| Project        | <b>IEEE 802.16 Broadband Wireless Access Working Group</b> < <a href="http://ieee802.org/16">http://ieee802.org/16</a> >   |         |  |
| Title          | <b>Control channel allocation for femto-cells</b>  |         |  |
| Re:            | TGm SDD: Femtocells  |         |  |
| Purpose        | Actions: 1. Modification of ToC 2. Capture of the text in the SDD  |         |  |

Fig. xx Control channel allocations for macro cells and femto cells

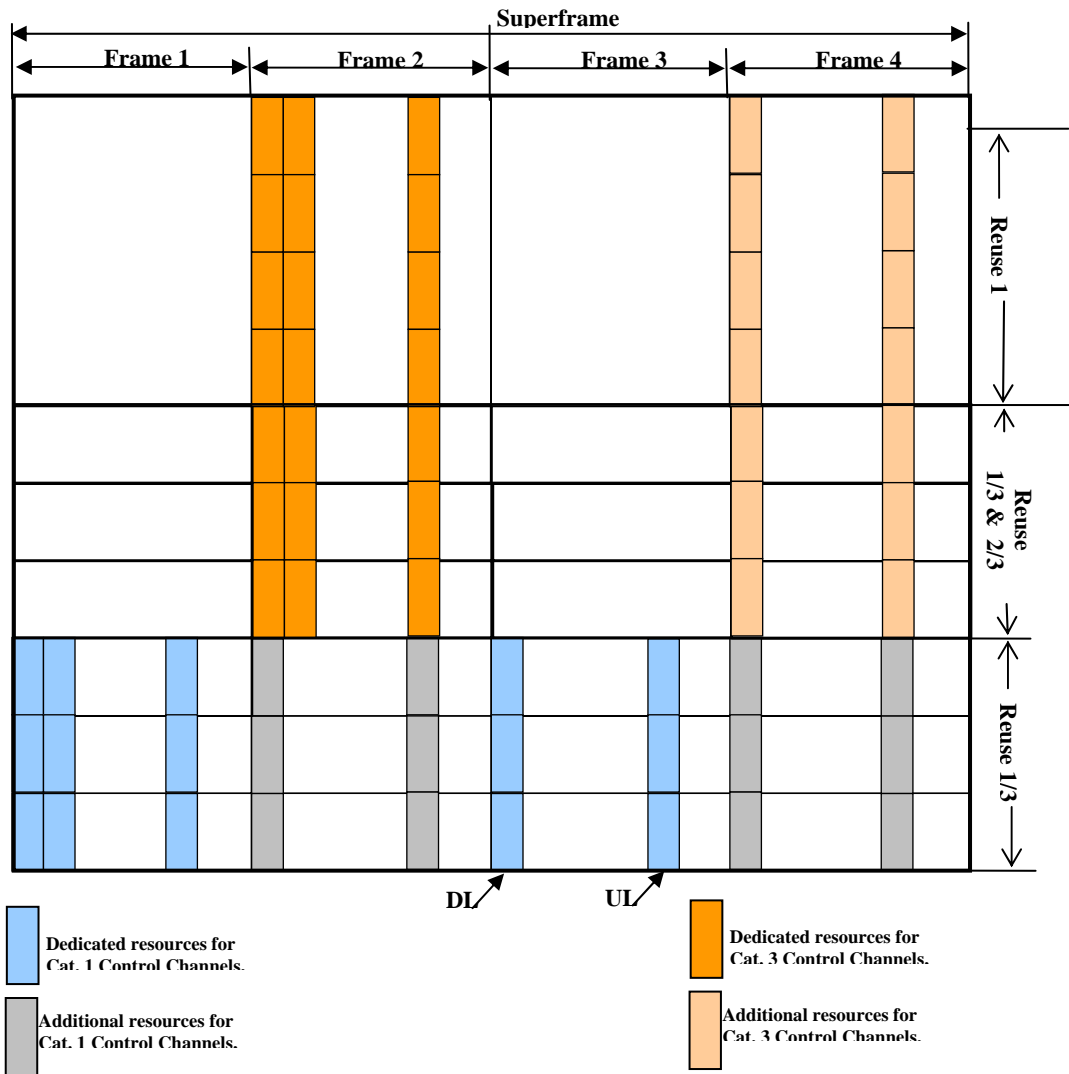
The femto-cells are a special deployment category, which has potential for creating harmful interference to a MS associated with a macro-cell, on both co-channel and adjacent channels operation. The allocation of the Control Channels needs to be adapted for including heterogeneous deployment categories in overlapping geographical areas.

The allocation of the control channels for femto-cells, including the superframe start, will use a different frame from the frame used by the macro-cells for their superframe start. The OFDMA partitions used for the superframe control channels of the Femto-cells shall be different from the Reuse 1/3 partitions used by macro-

An example of control channel allocations, such to avoid the interference to macro-cells, is given in fig. xx.

In this example, the control channels for macro-cells are active each frame, but their reception with minimum interference is provided only during the frames 1 and 3. During these frames the femto-cells refrain from the transmission of the control channels.
